# Blue Mountains Conservation Society Inc

**Proposed redevelopment of Katoomba Christian Convention Centre, 119 Cliff Drive  
and 34 Violet St Katoomba Reference: X/163/2018**

Photo F/F 2: *Eucalyptus sieberi* Moist Open-forest with *Banksia cunninghamii* tall shrub layer and ground layer of ferns (near Eagle Hawk Lookout); would be subject to considerable disturbance by auditorium redevelopment

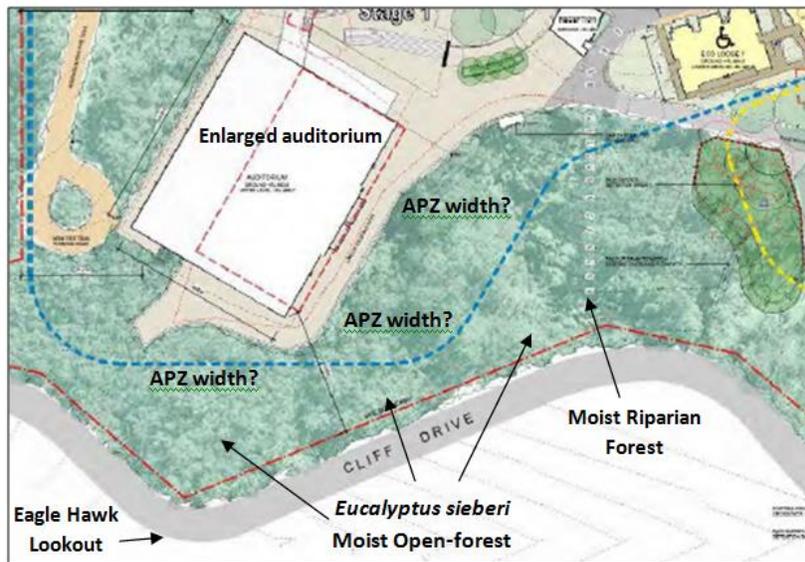
4. **We are concerned about the vegetation community classification for the eastern slope** of 119 Cliff Drive below both the present and newly proposed auditoriums. Travers Ecology (p. 19) mapped this area as **Dry Open Forest (*Eucalyptus piperita* & *E. sieberi*)** and note that the majority of the community is highly disturbed. They then go on to say (p.20) that there is *a relatively undisturbed variation of this community within the far southeast of the subject site*. **That is all that is said about a community that occupies almost the entire eastern slope** and which merges into and surrounds a gully of Tree Ferns that has been designated a Moist Riparian Forest.

The growing conditions of the eastern slope community are quite different to the remainder of 119 Cliff Drive. When viewed from the edges of Cliff Drive near Eagle Hawk Lookout (refer to map F/F 1 below) the steepness of the slope is obvious, moisture levels and seepage rates are high and the bedrock highly weathered. The canopy is mostly dominated by *Eucalyptus sieberi* with *Banksia cunninghamii* dominating the tall shrub layer. There is also a dense and diverse understorey of many moisture-tolerant plants. **In this discussion this vegetation community will be referred to as the *Eucalyptus sieberi* Moist Open-forest** (photo F/F 2).

From the plans included in the Flora and Fauna Assessment it seems that **the expanded auditorium and associated roadways and some parking will intruded into the upper part of the *Eucalyptus sieberi* Moist Open-forest. It is not clear from the Flora and Fauna maps how far the Asset Protection Zone (APZ) will extend from the auditorium (usually 50 to 100 metres) but given the limited distance between the auditorium and Cliff Drive (as little as 30 metres) then we consider that there will be substantial disturbance to this community by direct construction, APZ clearing and the edge-effects that degrade by increased exposure to drying sunlight and westerly winds and from changed drainage.**

Schedule 1 Bushfire Protection Measures (a map) in the **Bushfire Hazard Assessment** (from Travers Ecology) in fact **confirms that our estimates of the degree of APZ intrusion into the vegetation of the eastern slope are correct.** As shown on Scheduled 1, **to accommodate the “inner and outer” APZs on the eastern side of the auditorium, all vegetation downslope to the edge of Cliff Drive will be cleared or seriously disturbed – this is completely unacceptable.** In the Inner APZ only 25-30% of the understorey will be retained and mowing will be a maintenance activity. Mowing is well documented as a seriously degrading activity near bushland. In the outer APZ that extends to Cliff Drive **up to 50% (and so possibly none) of the understorey will be retained in discontinuous clumps.** This is the area identified by us as the *Eucalyptus sieberi* Moist Open-forest and of which photographs F/F 2 to 4 were taken. **The eastern slope APZ clearance measures present a very serious threat to the survival of this fern-filled community where the retention of shade and soil moisture is critical for the survival of the current mix of species. It will be irrevocably changed.** This also undermines the applicant’s claim that the auditorium will be screened from view from points to the east e.g. Echo Point.
